-001 BRACKET

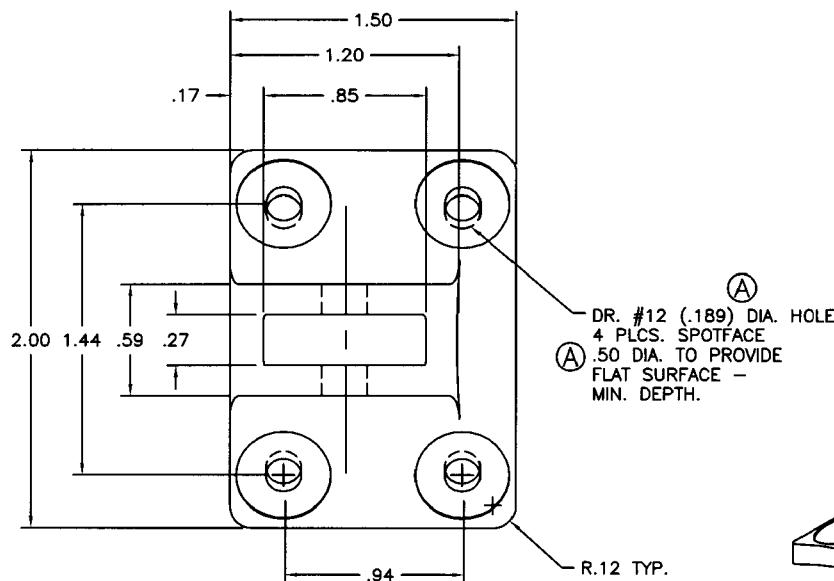
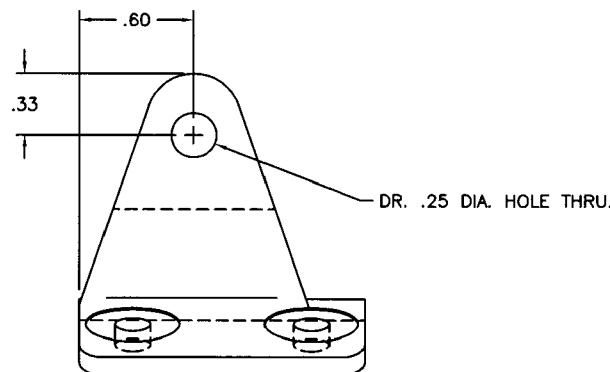
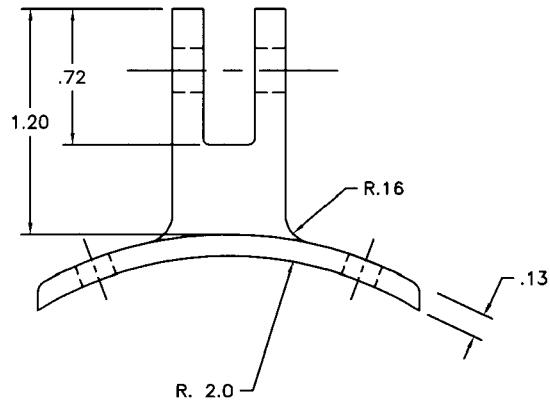
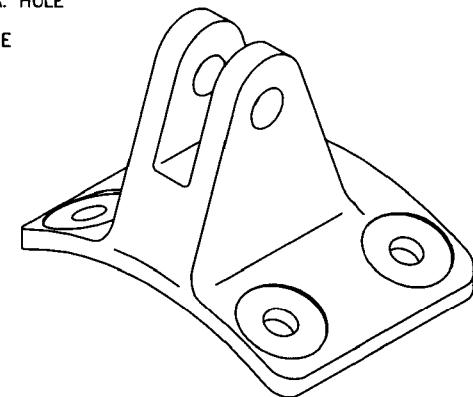
REVISION					
LETTER	DFTSMAN	DATE	DESCRIPTION	APPROVED	DATE
A	DNN	3/12/03	INCREASED DIMENSIONS OF HOLE & SPOTFACE; ADDED NOTE 1 & MAT'L SPEC; ADDED RADIUS DIM. TO CORNERS. MINOR CHANGE - FAR 21.95

▲ QQ-P-35 PASSIVATE FINISH. (A)
